Access Compliance Report

Public Rights-of-Way

(Curb Ramps)

Intersection ID: 25926	Main Street: ALDERMAN_LN	Cross Street: NEWCOMBE_CT	Location: NE
ADA ID: 1985FD9DEF29	Ramp Type: PerpDiag	Initial Pass/Fail: Fail	Overall Compliance: No
Severity Score: 22.5			
Codes/Mitigation Info/Possible Solution		Field Measurements/Component Compliance

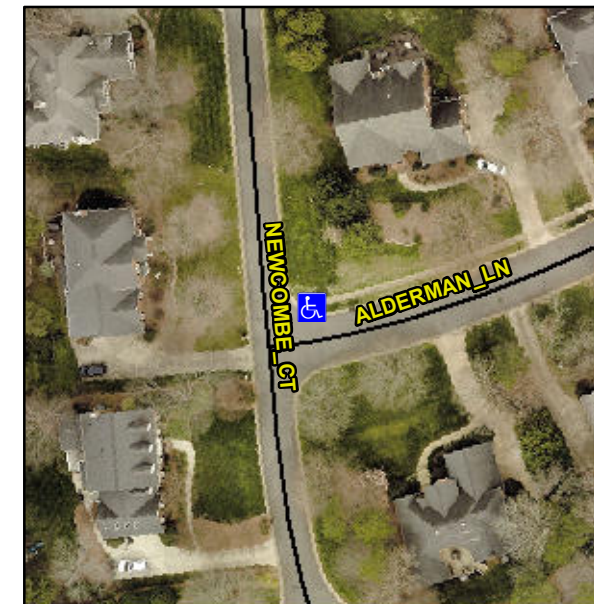
Not Found, R304.5.1, R304.2.2, R304.5.3

Compliance	Description	Data	Compliance	Description	Data
N/A	Ramp Length (in)	76.0	No	Ramp Slope (%)	10.2
No	Ramp Width (in)	38.0	No	Ramp XSlope (%)	3.1
N/A	Flare Type LT	N/A	N/A	Flare Type RT	N/A
N/A	Flare Slope LT (%)	N/A	N/A	Flare Slope RT (%)	N/A
N/A	Flare Traversable LT?	N/A	N/A	Flare Traversable RT?	N/A
N/A	Landing Length (in)	N/A	N/A	DWS Provided?	N/A
N/A	Landing Width (in)	N/A	N/A	DWS Contrast?	N/A
N/A	Landing Slope (%)	N/A	N/A	DWS Length (in)	N/A
N/A	Landing X Slope (%)	N/A	N/A	DWS Full Width?	N/A
N/A	Landing Curb? (Y/N)	N/A	N/A	DWS Offset (in)	N/A
N/A	Shared Landing?	N/A			
N/A	Gutter Ponding?	N/A	N/A	Gutter Slope (%)	N/A
N/A	Gutter Lip Ht (in)	N/A	N/A	Gutter X Slope (%)	N/A
N/A	Painted X Walk1?	No	N/A	Painted X Walk2?	No
	X Walk 1 Direction	To W		X Walk 2 Direction	To S
N/A	X Walk 1 Width (in)	N/A	N/A	X Walk 2 Width (in)	N/A
	X Walk 1 Slope (%)	2.9		X Walk 2 Slope (%)	4.0
	X Walk 1 X Slope (%)	1.3		X Walk 2 X Slope (%)	0.0

N/A	Ramp inside XWalk1?	N/A	N/A	Ramp inside XWalk2?	N/A
	Road Slope (%)	1.5	N/A	Clear Space?	N/A
	Road X Slope (%)	2.9	N/A	Clear Space to XWalk (in)	N/A
N/A	Any Obstructions?	N/A	N/A	Storm Grate/Utility Hazard?	N/A
	Obstruction Type			Storm Grate/Utility Type	
		N/A			N/A
		Yes		Surface Condition? (G/P)	Good

Remove & Replace Curb Ramp With Two New Directional Ramps or Equivalent.
